Internal Ref: EXTERNAL/2024/0020

Inner West Council Response: SSD-76927247 – The Timberyards by RTL Co.

Property: Lots bound by Victoria Road, Sydenham Road, Farr Street and Mitchell Street, Marrickville NSW 2204

Figure 3: An excerpt from the submitted schematic analysis provided in Appendix J

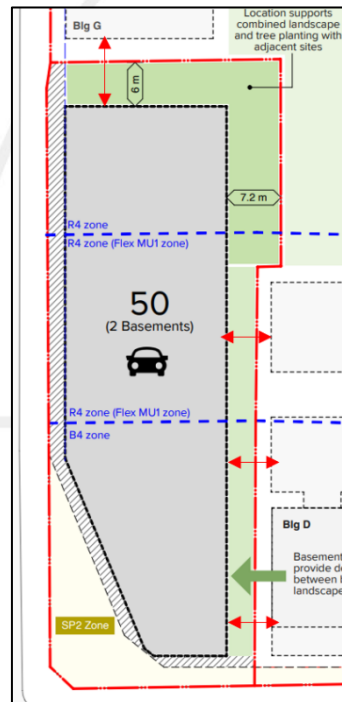
The schematic analysis has not adequately demonstrated that the adjoining Corner Site could support future development that is consistent with the relevant planning controls, including the vision of the *Indicative Masterplan*. It is noted that the schematic analysis unfairly burdens the Corner Site with the responsibility to provide compliant building separation distances contained in the Apartment Design Guideline (ADG) from adjoining properties (specifically buildings G and D), particularly given these buildings have only provided a minimum of 3 metre setbacks from the shared boundaries (as shown in red arrows below). In addition, it is unlikely that the site could provide sufficient communal open space that would receive a minimum 50% solar access for 3 hours on June 21, or receive compliant solar access to proposed residential

units, in accordance with the ADG given the extent of overshadowing to this area cast by the proposed development.

Should the sites remain as excluded from the SSDA and thus underdeveloped, they will be entirely overshadowed by the proposal on June 21.

It is considered that the submitted schematic analysis has not adequately demonstrated that orderly and economic use and development of the Corner Site could be achieved if acquisition is not pursued. The onus of providing compliant building separation, managing the SP2 zoning and upgrading the surrounding road network in accordance with s6.31(3)(a) of *IWLEP 2022*,
